April 1, 2009

Subject: Approval of Flow, Entrainment and Impingement Minimization Plan for
Tentative Order R9-2009-0038 amending Order R9-2006-0065 WDR for the Poseidon Resources
Seawater Desalination Plant Discharge to the Pacific Ocean via the Encina Power Station

Figure 1

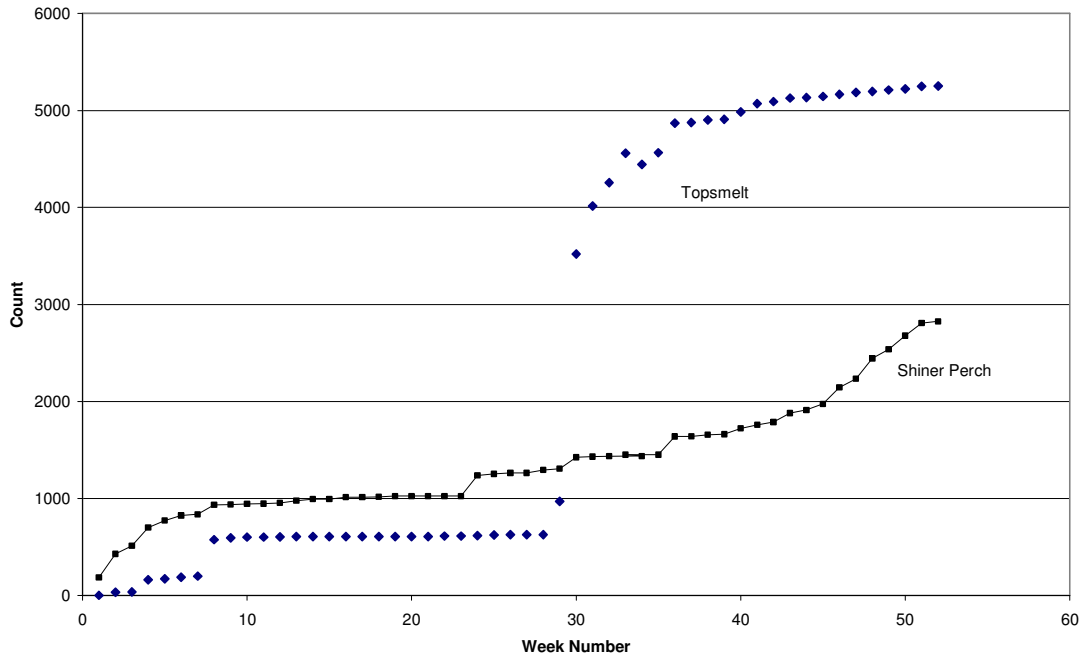
A concern that has received a good deal of attention is to explain why there was an exceptional increase in impingement data for two sample weeks; the 30th week, January 12-13, 2005 and February 23-24. Reference 5 treats these at “outliers” and does not provide a plausible reason. There is no discussion if the number of fishes in the source water beyond the small number of freshwater fish that were impinged due to immigration. An examination of the species that were impinged shows high number of the topsmelt impingement count, 2551, compared to prior values and compared to the shiner surfperch. This is illustrated by computing the cumulative counts of these two species over the 52 week period and comparing the results. This integration procedure

provides a trend in the impingement over time. Refer to the Figure 1 attached at the end of this letter. Note that the topsmelt shows the discontinuity in the cumulative count at the January 12-13 sample, whereas, the shiner perch does not. The number of shark/rays also show a jump in numbers compared to the past trend. These are relatively large predators and one reason for their increase is that they were attracted to the high numbers of fish in the tunnels.
